**FINAL**  
**NAVAL AIR STATION ALAMEDA RESTORATION ADVISORY BOARD**  
**MEETING SUMMARY**

July 7, 2005

**RAB REVIEW OF REVISED DRAFT FEASIBILITY STUDY REPORT, IR SITE 1,  
ALAMEDA POINT, VOLUME 1, PARTS A AND B, CTO 0068/0066, MAY 2005**

Subject: Review of Revised Draft Feasibility Study Report, IR Site 1, Alameda Point, Volume I, Parts A and B, CTO - 0068/0066, May 2005 (1)

EXHIBIT I

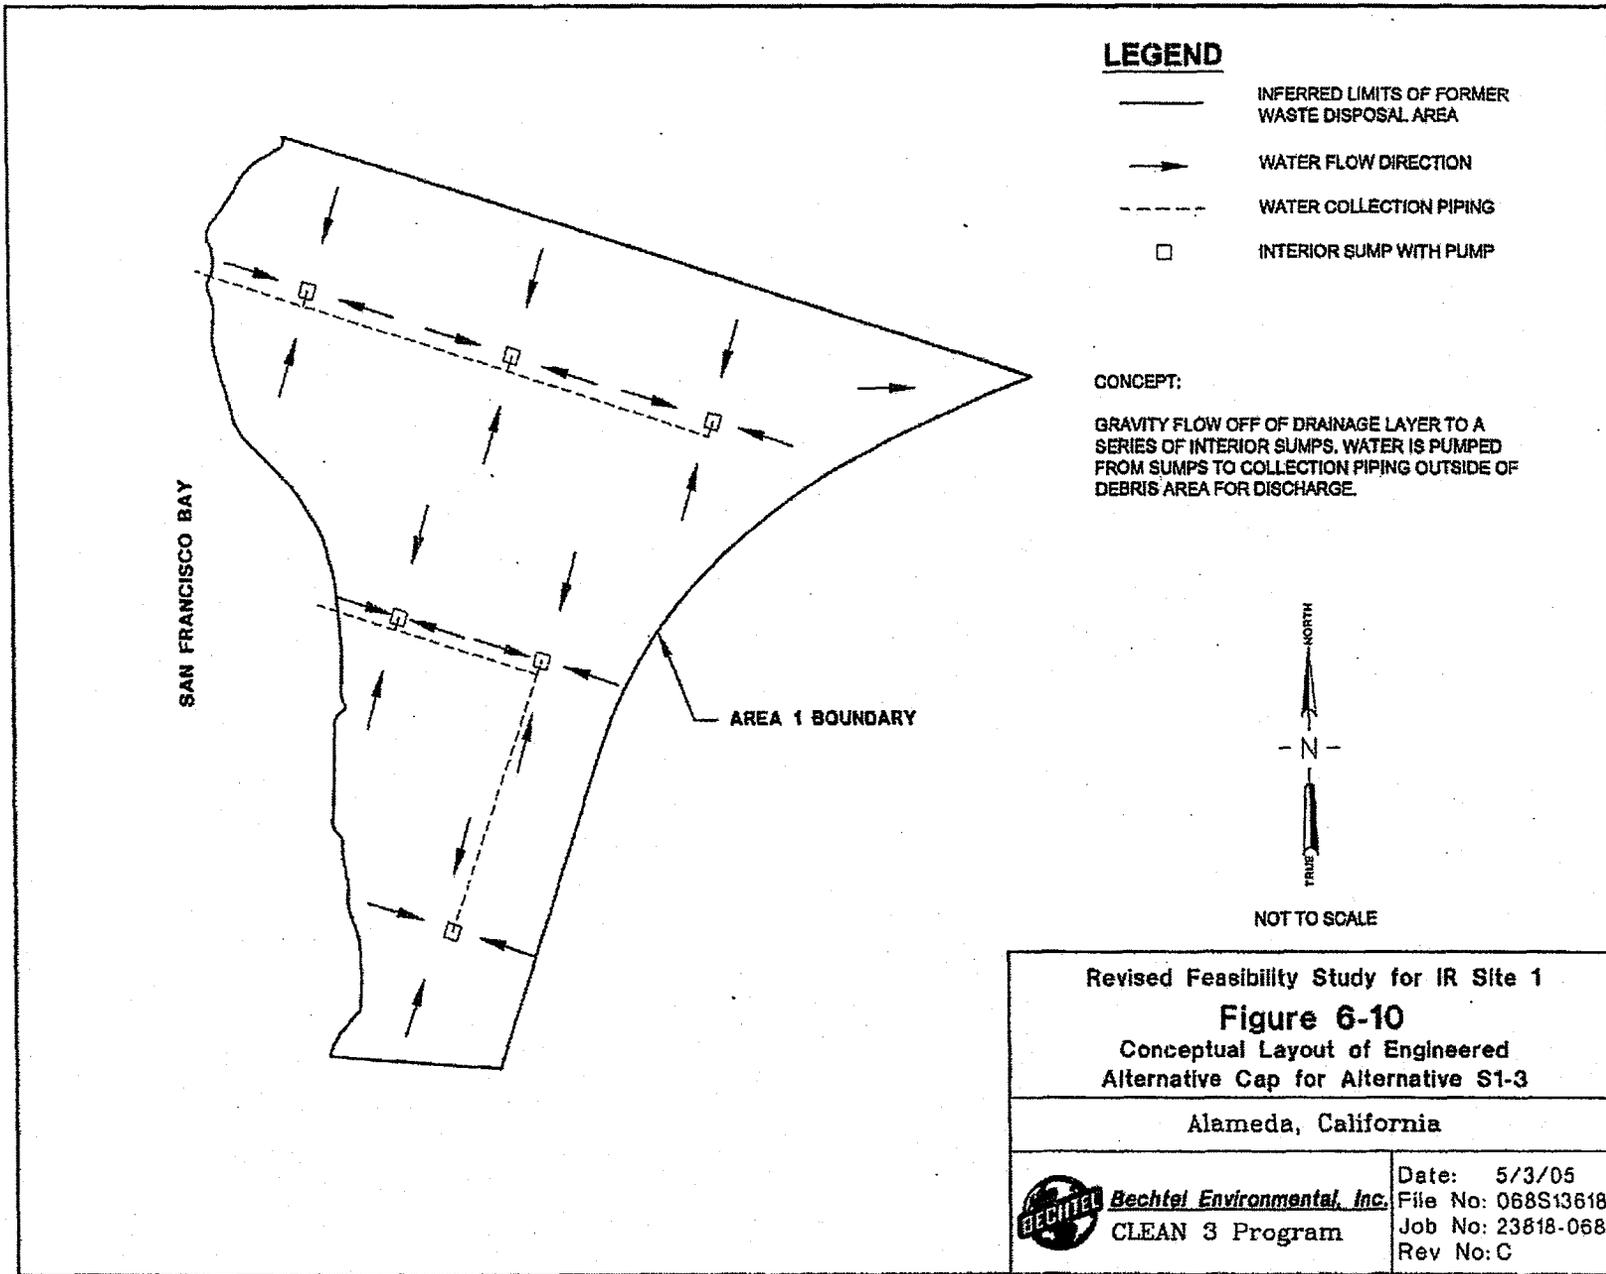
What is proposed herein (see Exhibit 1) is a slurry cut-off wall surrounding the waste cell area keyed into the younger bay mud, and a top cap comprised of clay, (probably bentonite), both structures meeting RCRA permeability standards. The bottom of the "containment" would consist of the younger bay mud layer underlying the site. The report (ref. 1, page 2-9 and 2-19) indicates that the highest contaminant levels occur in the first water-bearing zone and that the chemical plume has not yet dispersed into the second water-bearing zone. Therefore, the younger bay mud may form an adequate "bottom" for the containment. If this is not true, then the cut-off wall could be taken down to the older bay mud stratum. The younger bay mud layer would have to be at least 5 ft thick to provide a sufficiently thick base into which the cut-of wall could be keyed.

**EXHIBIT-3**

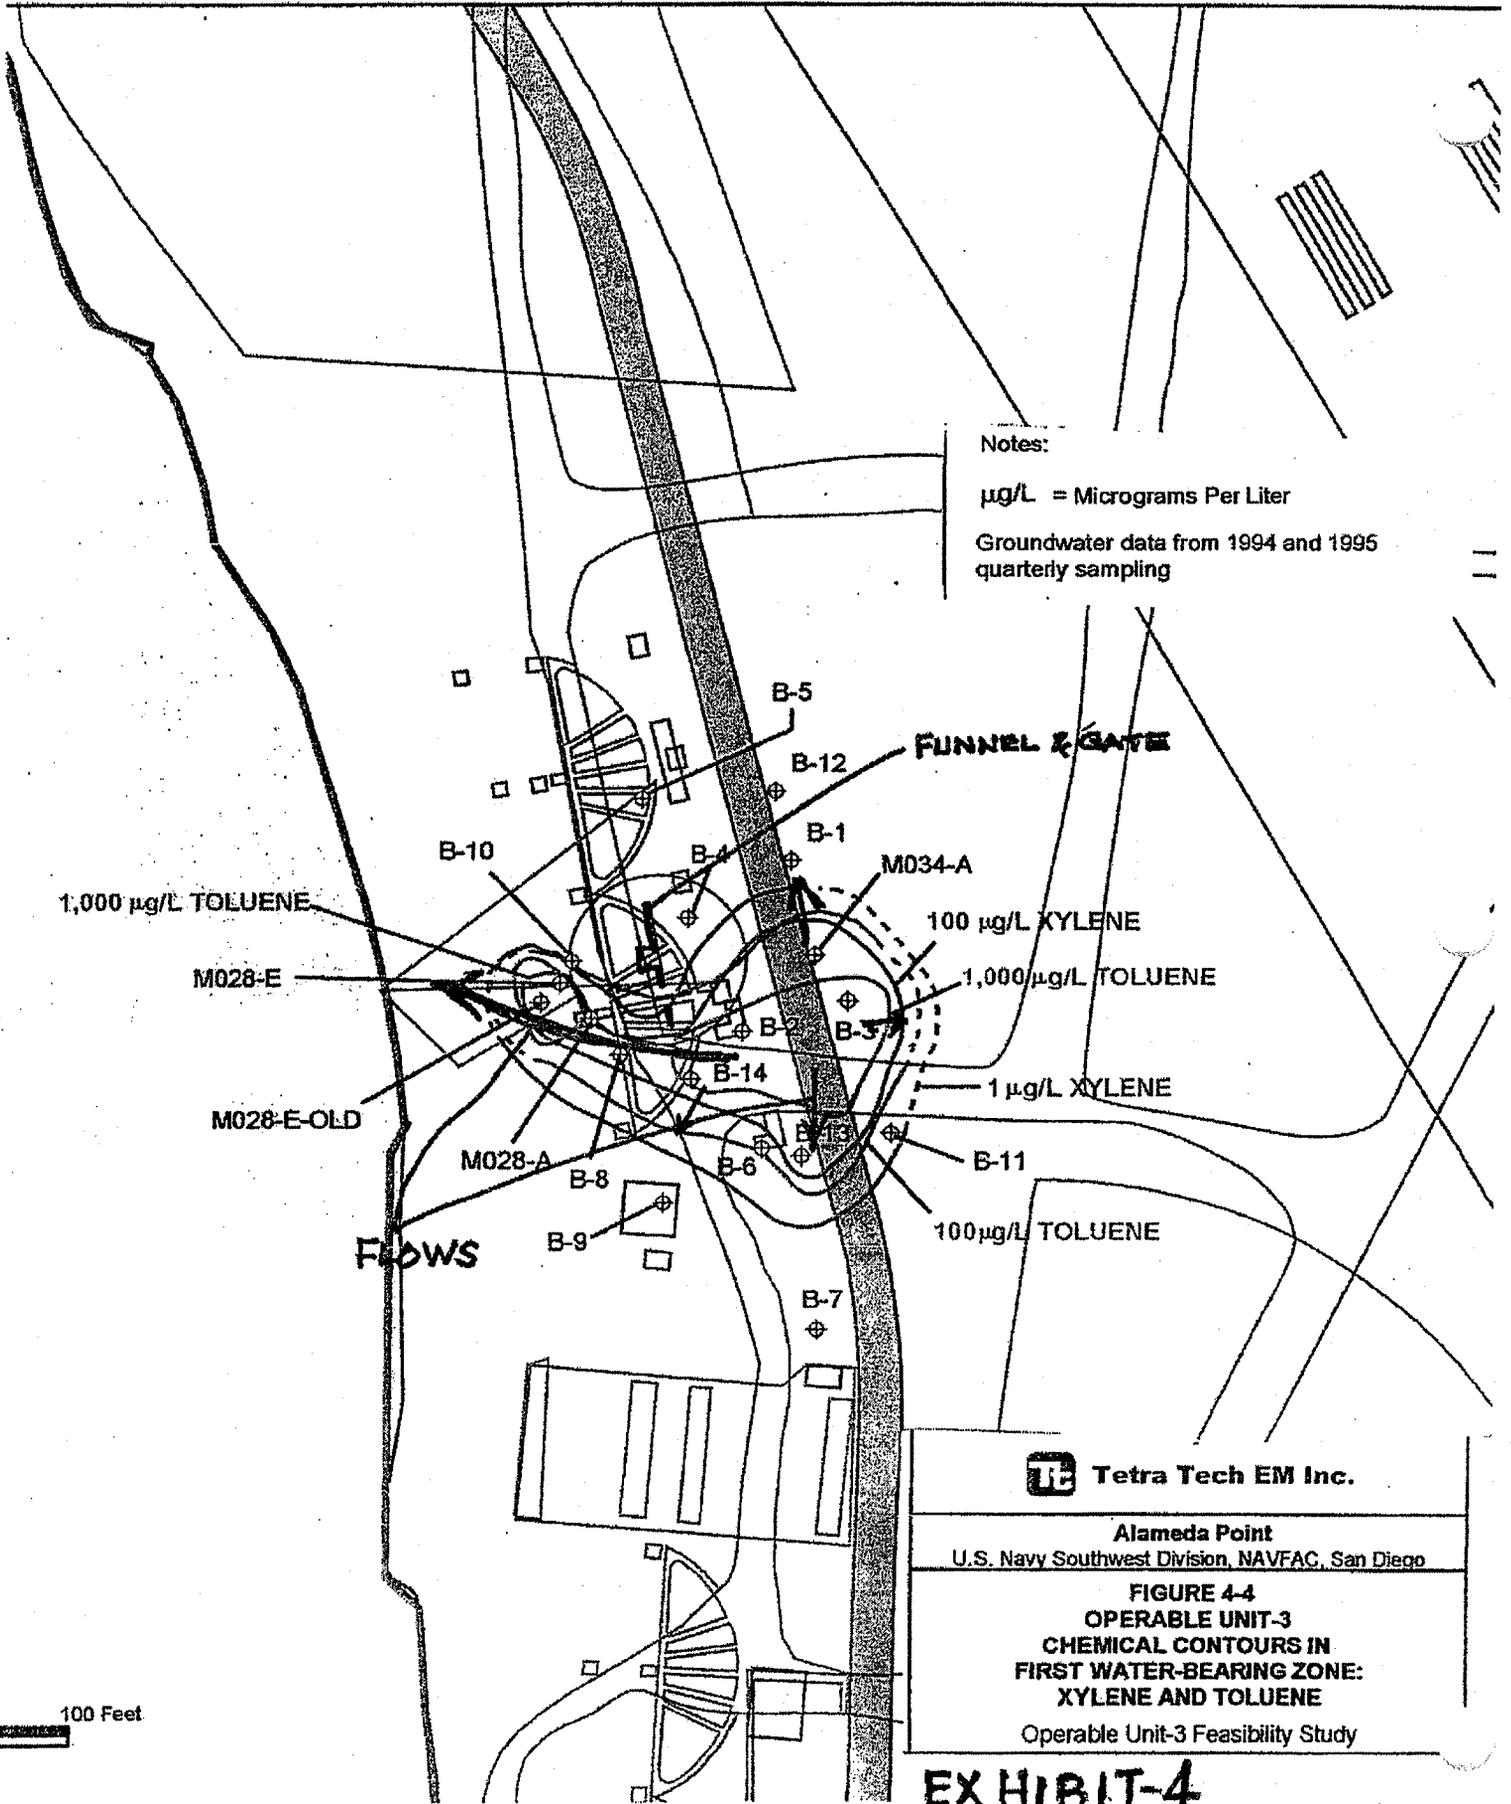
Mr. Humphreys continued with Exhibit 3 and 4 of his comments. Mr. Humphreys noted that Exhibit 3 presents the groundwater plume in this feasibility study by Bechtel, and Exhibit 4 presents the plume in an earlier feasibility study by Tetra Tech. Mr. Humphreys has provided directions of flow on these exhibits to show how the plume to the west appears to be bypassing the funnel and gate treatment system and how the other, larger, component of the plume is moving toward the southwest. The flow is crossing the treatment section of the funnel and gate system. Mr. Humphreys also noted that this same flow is suggested on Exhibit 4 and is bypassing the funnel and gate system, which he added to the figure for reference.

Exhibit 3 is a Figure from the most recent Feasibility Study (1) depicting the extent of the chlorinated solvent plume within the landfill. This can be compared with the shape of the contamination plume from the earlier 2002 Feasibility Study (2), shown as Exhibit 4. The 2002 FS contamination plume shows contours (1994-95 data) for xylene and toluene; whereas, the most recent plume is for the chlorinated volatile organic compounds. The two figures depict the same contamination plume, just for different constituents and reflect changes which have occurred over time (approx. 8 to 10 years). Another important feature to note is the "funnel and gate" treatment system as called out on Exhibit 3. The funnel and gate system is shown schematically in Exhibit 5. Note that the system is comprised of a "remedial gate" section and a "control gate" section. Groundwater flowing through the remedial gate passes successively through a sand bed containing granular iron (intended to remove chlorine from the chlorinated solvents) and then through a biosparging section (intended to oxidize and remove organic hydrocarbons, including those which have been stripped of chlorine).

EXHIBIT-6

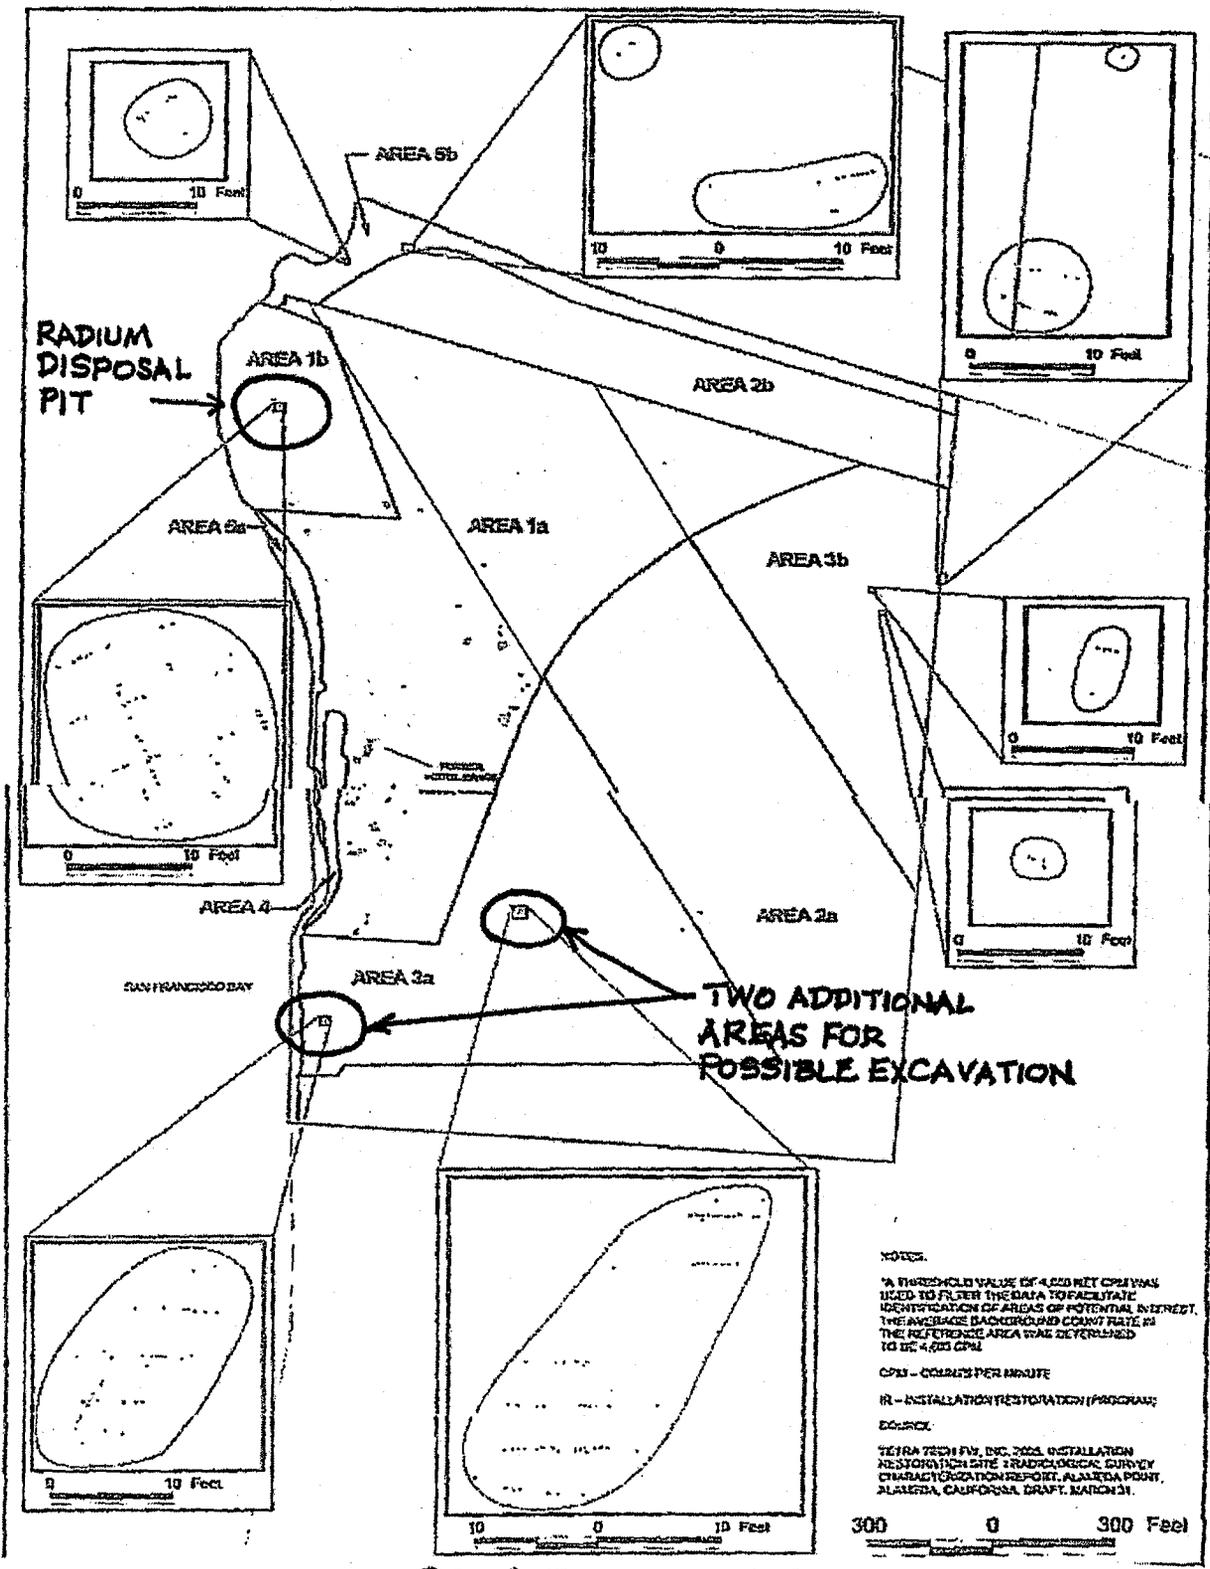
Mr. Humphreys referred to Exhibit 6 to show groundwater elevations at 5- and 4-foot elevation contours (feet above mean sea level). The surface of the site is about 8 feet above sea level, so groundwater is about 3 and 4 feet below grade. The flow in one instance is toward the estuary and in another case is toward the north and generally westward across the site. The immediate area of the funnel and gate system is working to the southwest.
